May 8, 2007

Project No.: 013-6054

RE: REVISED RI/FS WORK PLAN ADDENDUM #2  
ADDITIONAL GROUNDWATER TRANSECTS  
LIGHTMAN DRUM COMPANY SITE, WINSLOW TOWNSHIP, NJ

**FIGURE 1**

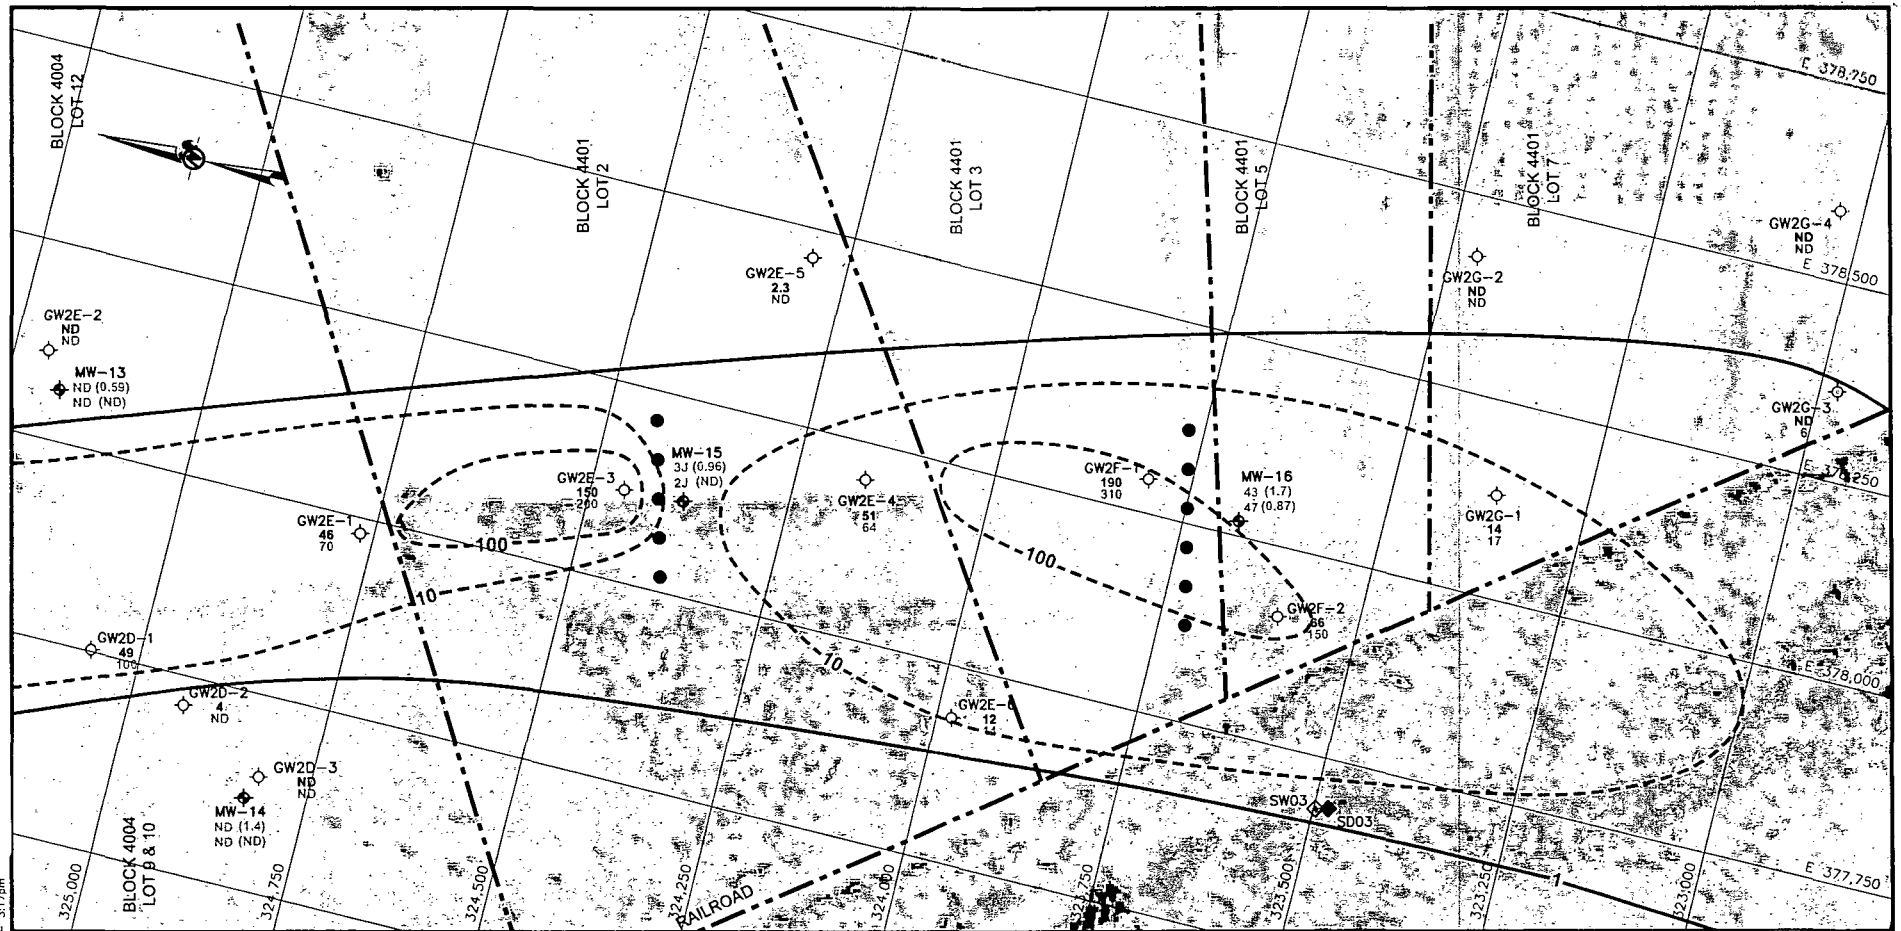
On behalf of the Lightman Yard PRP Group (Group), Golder Associates Inc. (Golder) has prepared this Revised Addendum #2 to the Remedial Investigation/Feasibility Study (RI/FS) Work Plan (Golder, 2002) for the Lightman Drum Company Site (Site) located in Winslow Township, New Jersey. The Addendum was originally submitted pursuant to the United States Environmental Protection Agency (USEPA) request in their letter dated March 6, 2007 and includes additional hydrogeologic investigations downgradient of the Site consisting of eleven aquifer profile borings. The revisions to this Addendum address USEPA comments contained in a letter received on April 30, 2007. The Site background, investigation objectives and scope of work for the additional investigation are described herein and the locations of the proposed work area shown in Figures 1 and 2.
